MANDATORY SERVICE BULLETIN

MSB 42-148

MSB 42NG-094

Replacement of the main landing gear (MLG) and nose landing gear (NLG) retaining rings.

1	Pull and tag the GEAR circuit breaker to prevent inadvertent landing gear operation.
2	<p>Locate the retaining rings. See Figure 1 for MLG locations and Figure 2 for NLG locations.</p>  <p style="text-align: center;">Figure 1: MLG Retaining Rings</p>

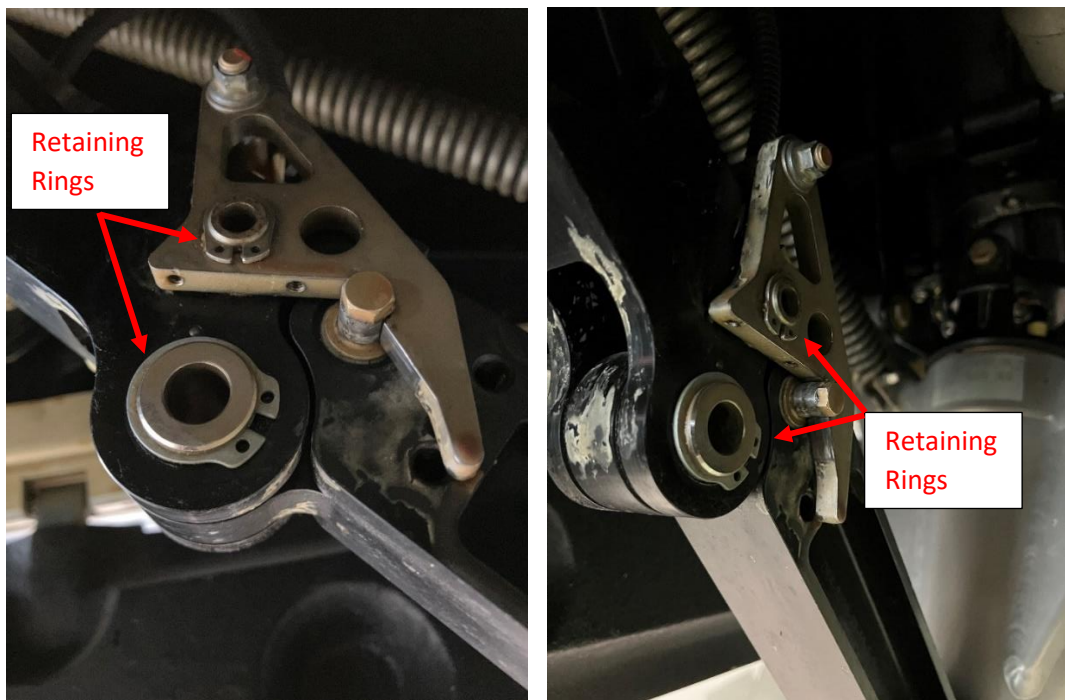
It was discovered that the main and nose landing gear braces of some aircraft had retaining rings with insufficient level of corrosion resistance being installed. This may cause the retaining rings to corrode, sustain damage, or fail (crack). If not corrected, this may lead to failure of the landing gear. This Service Bulletin describes the replacement of those retaining rings.

3	Replace one retaining ring at a time.
4	Remove the retaining rings from the MLG legs and NLG leg as per the figures. (Refer to Figures 1 and 2 for location)
5	<p>CAUTION: Do not remove or move shafts while replacing retaining rings:</p> <p>Clean the grooves of the bearing shafts. Inspect the folding stay and bearing shafts for general condition before installing the new retaining rings.</p> <p>NOTE: If for any reason the folding stay, and/or the bearing shaft needs to be removed for repair / replacement / further inspection, perform work in accordance with AMM section 32-00, then proceed to step 6.</p>
6	<p>NOTE: Do not overstretch the retaining rings during installation. Open the rings only enough to fit over the shaft when installing.</p> <p>Install the new retaining rings. Make sure the retaining rings properly engage into the grooves of the bearing shafts.</p>
7	Clean working areas, check for foreign objects.
